# ZONING PERMIT APPLICATION

**Aitkin County  
Zoning/Environmental Services**

**FIELD EVALUATION SHEET**

## Geoflow Subsurface Dripline Disposal Field Calculation

PLAN NORTH  
 LOT 11 BLOCK 1 CEDAROSA 1ST ADDITION  
 CLARK J. GROTT, OWNER. 1" = 20'-0" 9-19-97

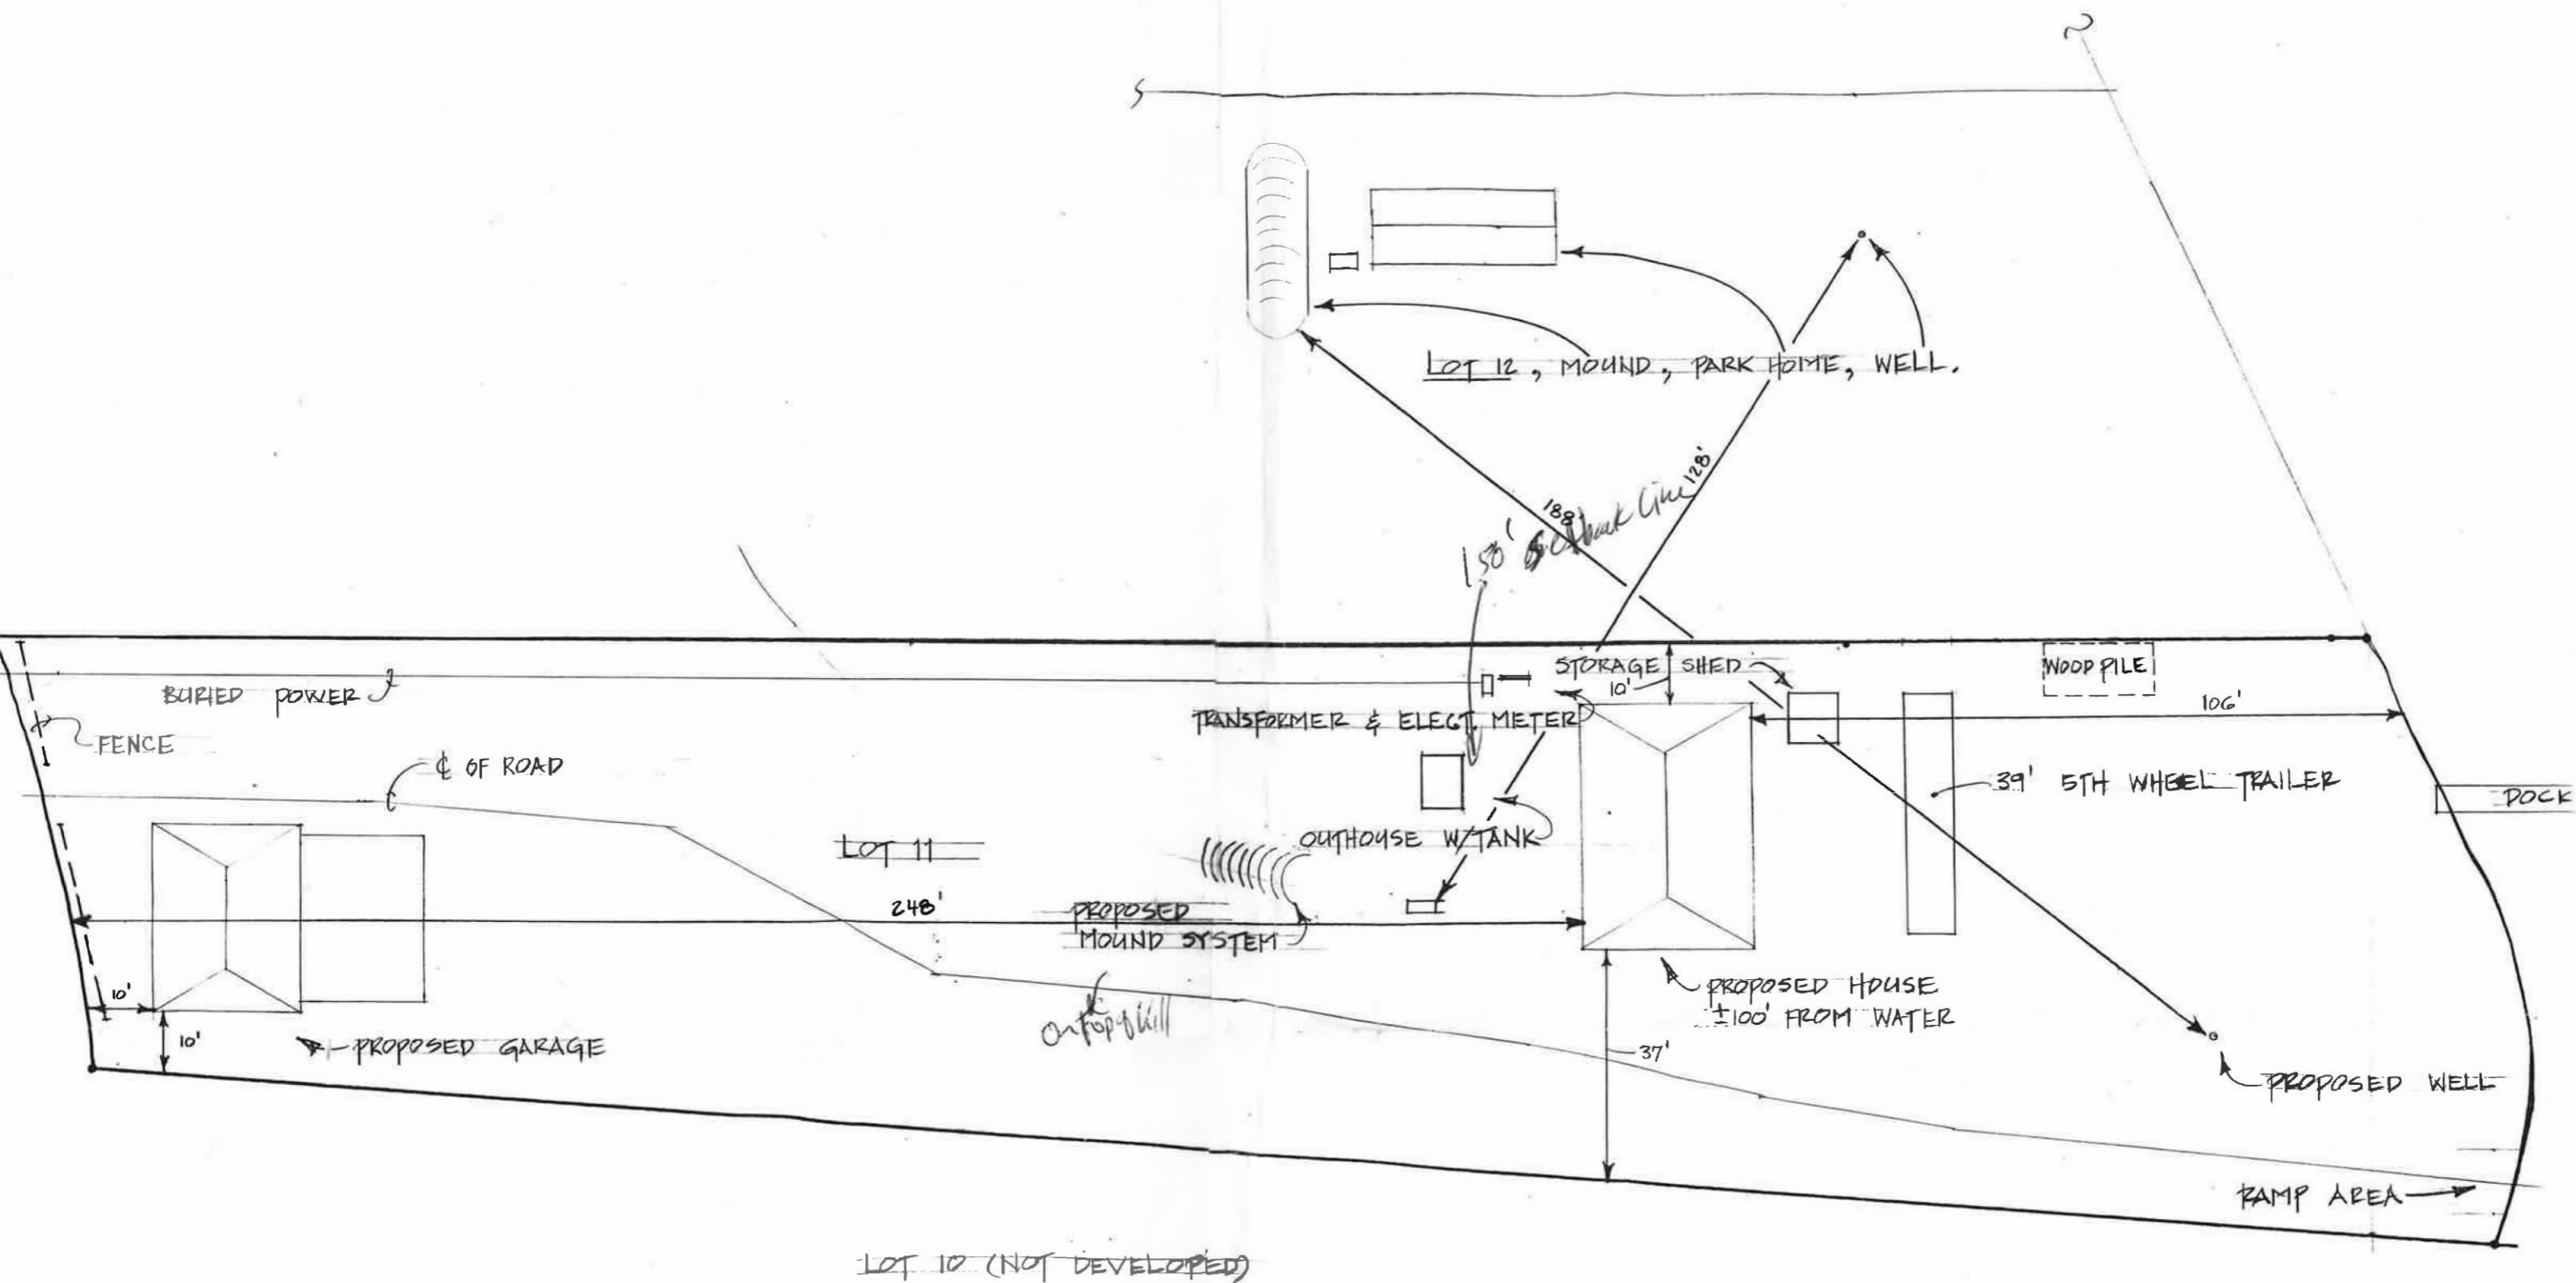
Find out WHAT TYPE of  
DRIPPER LINE HE IS  
Using

MAKE SURE HE HAS TEST  
HOLES WITH PEA ROCK OR  
WASHED SANDS AROUND THEM.

- elev. pump to manifold
- size of pipeline & length
- determined 15 PSI Case 908  
into dripper line Geo Flow  
Wack Sheet
- Waste Flow Classic  
dripper line

**DRAWING OF SYSTEM**

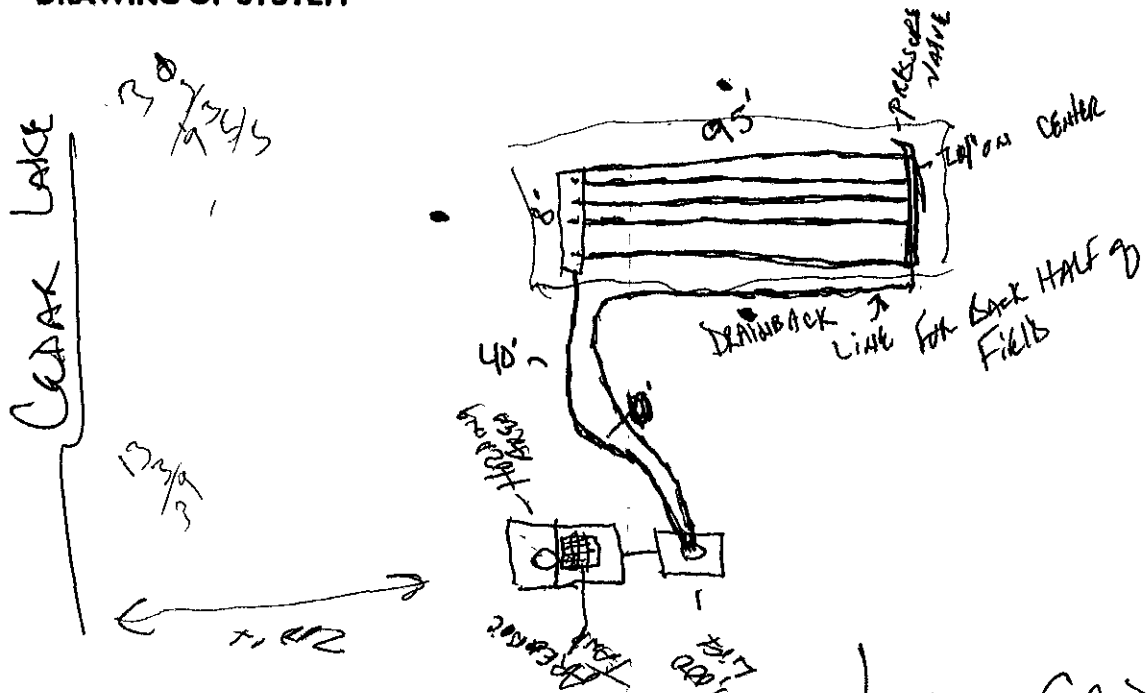
Inspector's Comments \_\_\_\_\_ Loamy SAND TO COVER LINE
